**NUMBER:** 08-003-21

**This bulletin supersedes Technical Service Bulletin 08-074-20 REV. F, date of issue December 03, 2020, which should be removed from your files. All revisions are highlighted with **\*\*asterisks\*\*** includes additional notes.**

Improved Steering Feel

2018 - 2020	(JL)	Jeep Wrangler
2020	(JT)	Jeep Gladiator

Fig. 1

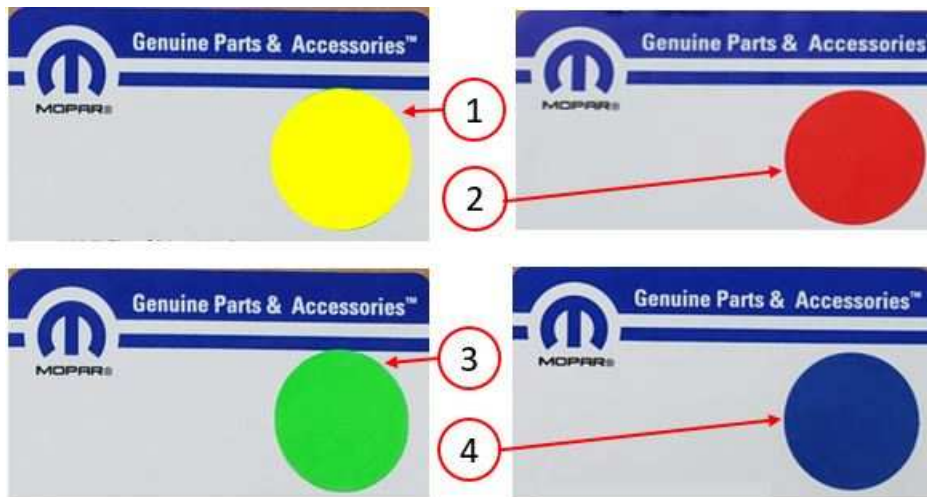
The Steering Gear Parts Label Has A Color Dot On It To Help Confirm The Correct Steering Gear Was Ordered

- 1 - Yellow Dot, 68507576AA (JT Left Hand Drive (LHD))
- 2 - Red Dot, 68507569AA (JL 4 Door LHD, **W/O EXJ 3.0 Diesel**)
- 3 - Green Dot, 68507574AA (JL 4 Door LHD, **With EXJ 3.0 Diesel**)
- 4 - Blue Dot, 68507571AA (JL 2 Door LHD)
